项次	REVISIONS	REC.	DATE	项次	REVISIONS	REC.	DATE
1	0.30mm深度的圆弧填平		2025.01.06	4	四个角填平，⑩尺寸由1.60改为2.00		2025.02.11
2	填高0.40mm，⑧尺寸由12.70改为12.70MAX		2025.01.06	5	4个支点向内侧加粗，改为1.60X1.80		2026.08.28
3	⑩尺寸由1.80改为1.60，⑥尺寸由1.80改为2.40		2025.01.06	6			
DRAWN & DRAFTED BY		LIU WEI QIANG		TOLERANCES		ANGLE: ±1	
CHECKED & APPROVED BY		LIN JUN		0<L≤4 ±0.1		UNIT: MM	
				4<L≤16 ±0.2		TITLE: T18201-382B BASE	
				16<L≤63 ±0.3		BOBBIN MATERIAL: PHENOLIC	
				pin pitch ±0.2		UL REC. UL 94V-0	
						PIN MATERIAL: CP WIRE	
						PIN TENSION LOAD: 0.8KG MIN	
						DATE: 2024.12.09	
						DRAWING NO. ZX-B189	
						REV. A04

智信电子塑胶有限公司

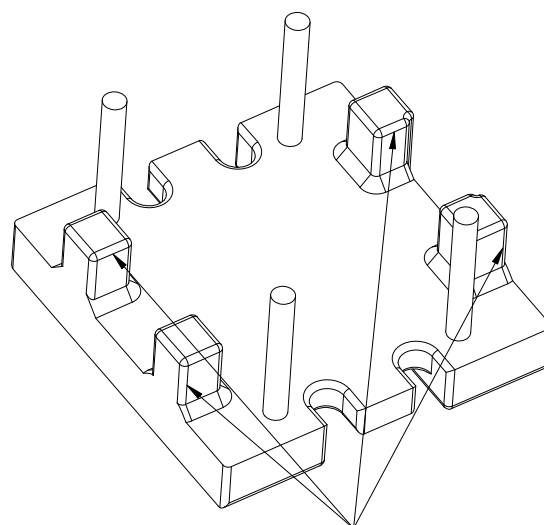
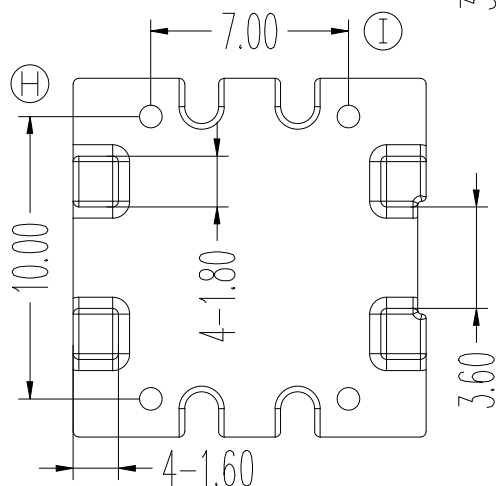
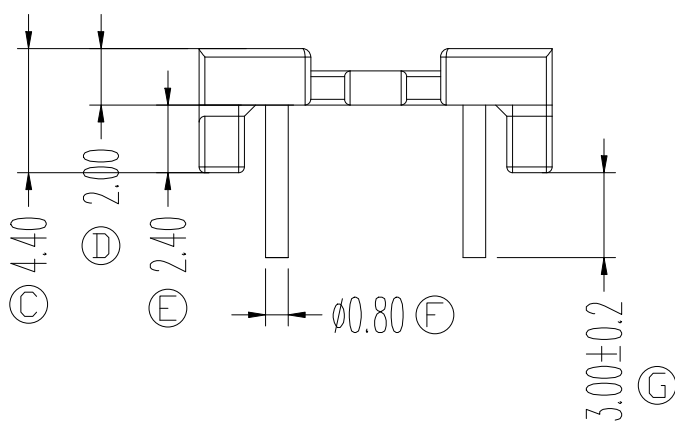
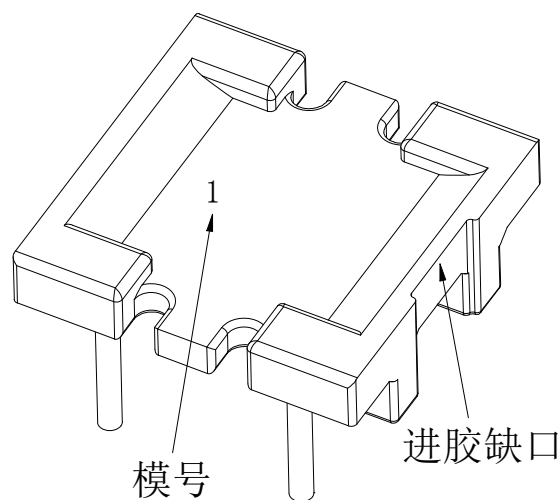
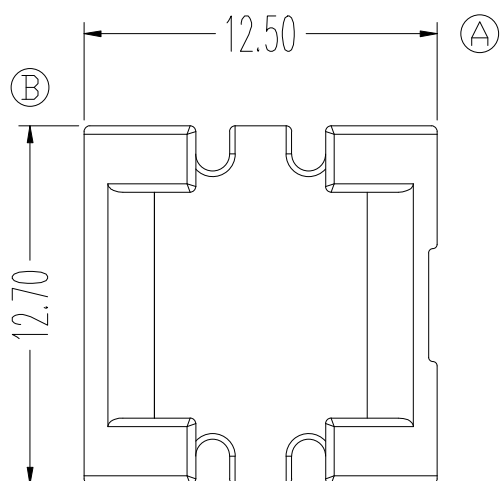
4个支点向内侧加粗，
改为1.60X1.80
